PETITION #2019-039
MALLARD CREEK NEIGHBORHOOD
 CHARLOTTE, NORTH CAROLINA
 DEPENDABLE DEVELOPMENT, INC.

RZ-1

Rezoning Transportation Analysis

Petition Number: 2019-039

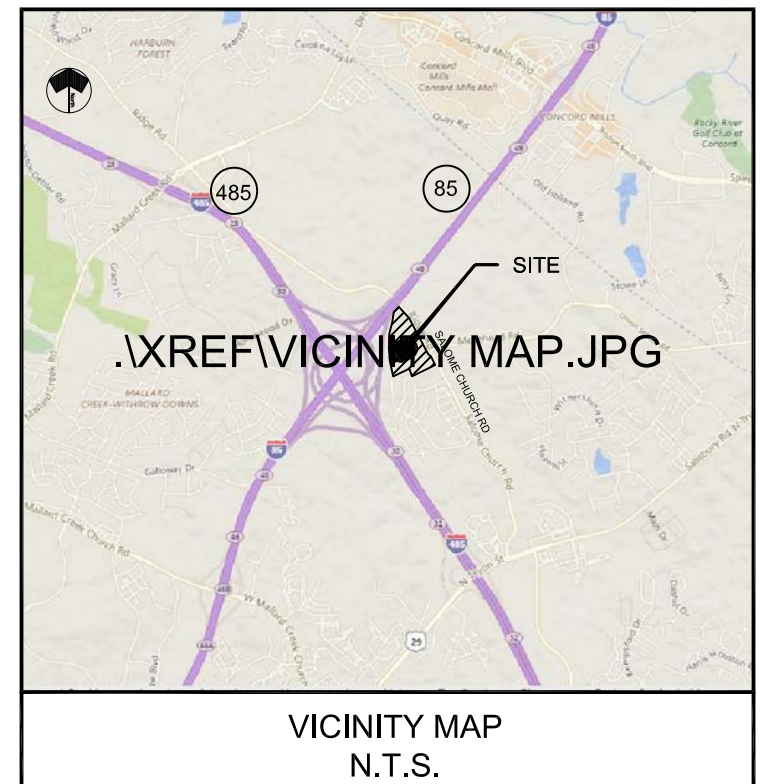
- Salome Church Road – 30 feet as measured from the road's existing centerline. The petitioner should update the site plan to commit to construct the curb and gutter at the location mentioned above. The site plan should label and dimension the curb and gutter from the road centerline.

2. ~~**Traffic Study:** A Traffic Impact Study is not necessary for the complete review of this petition.~~
3. The petitioner should revise the site plan and conditional note(s) to specify and implement a 12' multi-use path, 8' planting strip, and 2.5' curb and gutter along the site's Salome Church Road frontage and extending to the I-85 bridge.

5. **Comment revised.** The petitioner should revise the site plan and conditional note(s) to commit to ~~asymmetric~~ **symmetric** off-site roadway improvements, to provide two 11' wide southbound travel lanes, **one north bound travel lane**, and a northbound 11' left turn lane on Salome Church Rd. at the proposed access location. The left turn lane should provide 100' of storage capacity and a 100' bay taper.

DPR Response: Done. See revised Note. We added "asymmetric or symmetric" per our agreement at the meeting w/ Rick, Eric.
6. ~~The petitioner should revise the site plan and conditional note(s) to include the proposed public street connection to existing Porter Creek Road.~~
7. **Comment revised.** The petitioner should revise the site plan and conditional note(s) to specify and provide an 8' planting strip and ~~(6')~~ 8' sidewalk throughout the entire subdivision. Also, the 8' planting strips and ~~(6')~~ sidewalks along the site's proposed southern public street need to be extend to Salome Church Rd's 12' multi-use path. ~~This pedestrian connection will provide a direct pedestrian/bike connection to Salome Church Rd. and provide pedestrian access to Stoney Creek Elementary.~~

DPR Response: Done. See revised Note.
8. ~~The petitioner should revise the site plan to add a note specifying dedication and fee simple conveyance of all rights of way to the City before the site's first building certificate of occupancy is issued. CDOT requests a sidewalk utility easement at 2' behind back-of-sidewalk.~~
9. **New Comment:** The petitioner should revise the site plan's note 5.B, to specify that **all transportation improvements will be approved and constructed before the site's first building certificate of occupancy is issued.**

DPR Response: Done. See revised Note. CDOT & Petitioner agreed on 40th Building CO.
10. ~~The petitioner should revise site plan note 5D to state the petitioner commits to implementing traffic calming measures, including three (3) speed humps, stop signs, and 25 mph speed limit signs within the subdivision. These devices will be funded by the petitioner and their placement will be determined during the permitting process.~~
11. ~~The petitioner should revise the site plan to implement on-street recessed parking on both sides of the proposed public street that fronts the possible amenity area. Accessible on-street parking spaces should also be provided on both sides of the proposed public street.~~
